**Subject: Request for Additional Information Regarding Archer Daniels Midland (ADM)  
Well CCS #2, United States Environmental Protection Agency Underground  
Injection Control (UIC) Permit Application #IL-115-6A-0001**

## **Review of Plans Information in Archer Daniels Midland's (ADM) Permit Application for CCS #2 and Request for Additional Information**

## **Archer Daniels Midland (ADM) CCS #2 Permit Application Alternative Post-Injection Site Care (PISC) Timeframe Demonstration Review**

Attachment 4

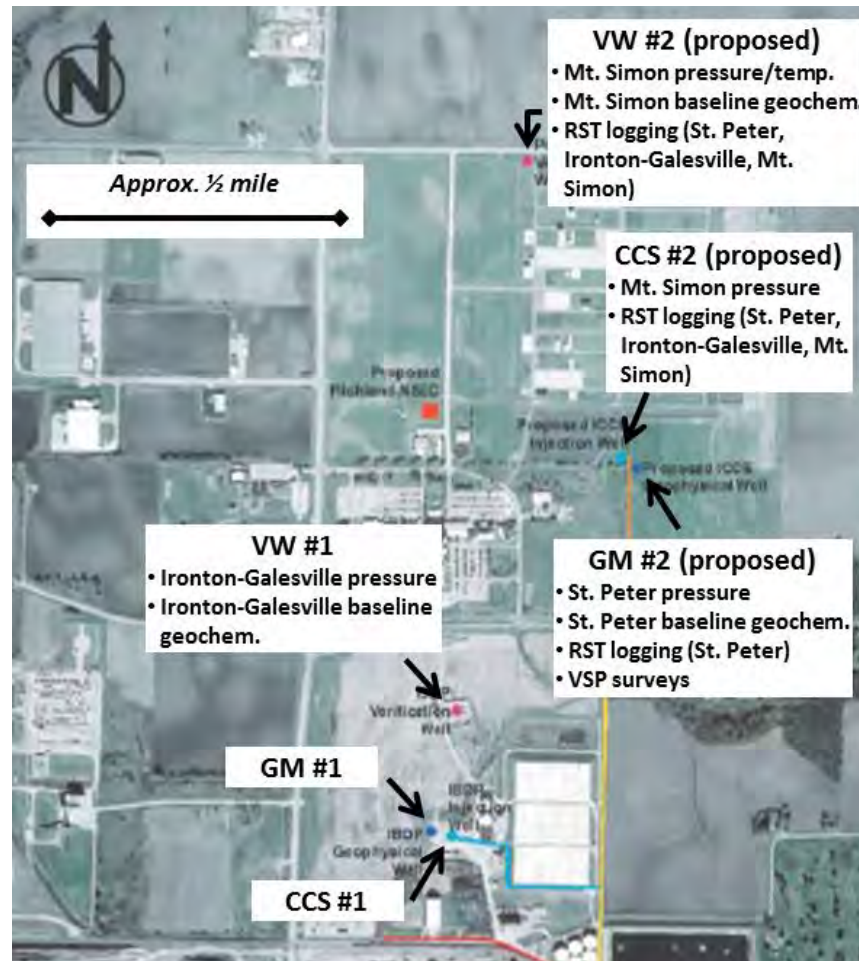
*Attachments 2 and 4 summarize EPA's understanding of where ADM proposes to perform ground water monitoring to meet the requirements at 40 CFR 146.90(d). Can ADM confirm that the information in these attached tables is accurate? If it is inaccurate, please provide the correct and current information on the proposed ground water monitoring approach.*

*Attachments 3 and 4 summarize EPA's understanding of where ADM proposes to conduct monitoring to meet the plume and pressure front tracking requirements at 40 CFR 146.90(g). Can ADM confirm that this is accurate? If it is inaccurate, please submit revised information.*

Location of injection wells and deep monitoring wells at the ADM site, with the planned monitoring activities for the IL-ICCS/CCS #2 project for each applicable well.
